ADDENDUM NO. I

DATE: November 29, 2016
TO: All Bidders
FROM: Janice McClelland, Assistant Purchasing Agent
SUBJECT: Addendum No. 1 – Pumper Trucks
BIDS TO BE OPENED: December 9, 2016 (new date – see below), at 11:00:00 a.m.

OFFICER SIDE

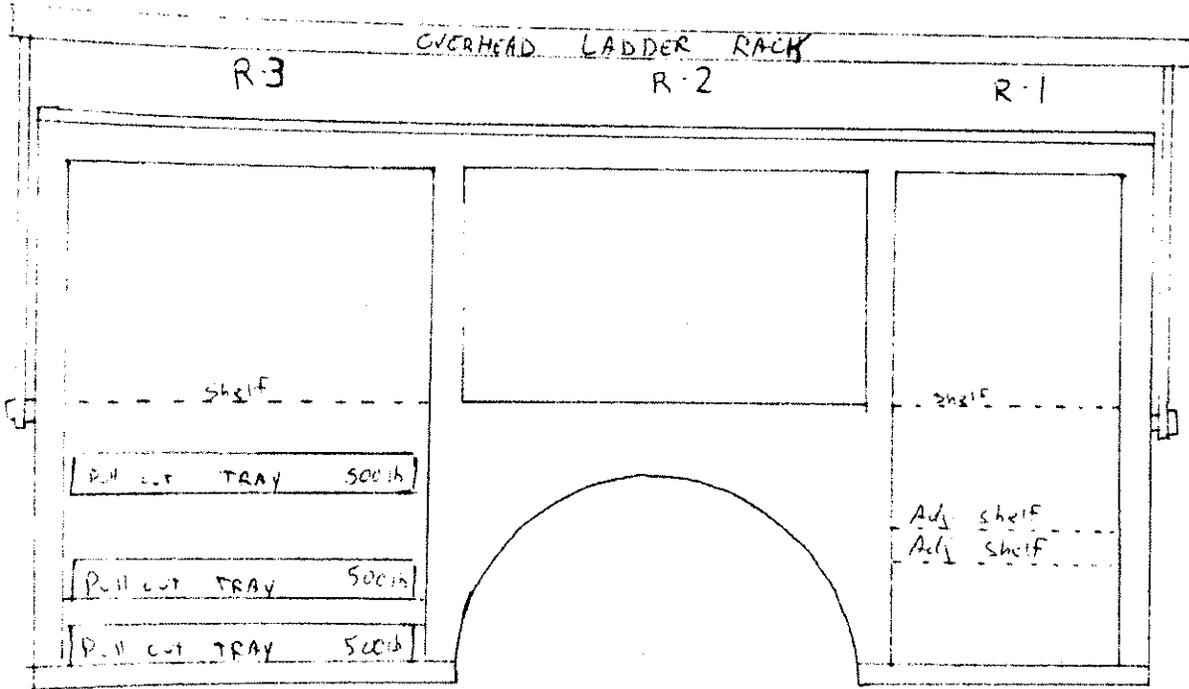
OFFICER SIDE COMPARTMENTS FULL HEIGHT OPTION

THE COMPARTMENTS ON THE OFFICER SIDE OF THE TRUCK SHALL BE MODIFIED TO BE FULL HEIGHT AND MIRROR THE DRIVER SIDE COMPARTMENTS OF THE TRUCK.

THE THREE (3) OFFICER SIDE COMPARTMENTS SHALL BE CONSTRUCTED FROM 3003 H14 1/8" (.125") SMOOTH ALUMINUM PLATE. THE COMPARTMENTS SHALL BE MODULAR IN DESIGN AND SHALL NOT BE A PART OF THE BODY SUPPORT STRUCTURE.

THERE SHALL BE ONE (1) COMPARTMENT LOCATED AHEAD OF THE REAR WHEELS. THIS COMPARTMENT SHALL BE APPROXIMATELY 30" WIDE X 68" HIGH X 26" DEEP IN THE LOWER 30" HIGH SECTION AND 12" DEEP IN THE UPPER 38" HIGH SECTION. THE COMPARTMENT SHALL CONTAIN APPROXIMATELY 21.5 CU. FT. OF COMBINED STORAGE SPACE. THE DOOR OPENING SHALL BE APPROXIMATELY 30" WIDE X 68" HIGH.

THERE SHALL BE ONE (1) COMPARTMENT LOCATED OVER THE REAR WHEEL. THE COMPARTMENT SHALL BE APPROXIMATELY 56" WIDE X 34" HIGH X 12" DEEP AND CONTAIN APPROXIMATELY 13.2 CU. FT. OF STORAGE SPACE. THE DOOR OPENING SHALL BE APPROXIMATELY 56" WIDE X 34" HIGH.

THERE SHALL BE ONE (1) COMPARTMENT LOCATED BEHIND OF THE REAR WHEELS. THIS COMPARTMENT SHALL BE APPROXIMATELY 50" WIDE X 68" HIGH X 26" DEEP IN THE LOWER 30" HIGH SECTION AND 12" DEEP IN THE UPPER 38" HIGH SECTION. THE COMPARTMENT SHALL CONTAIN APPROXIMATELY 35.8 CU. FT. OF COMBINED STORAGE SPACE. THE DOOR OPENING SHALL BE APPROXIMATELY 50" WIDE X 68" HIGH.
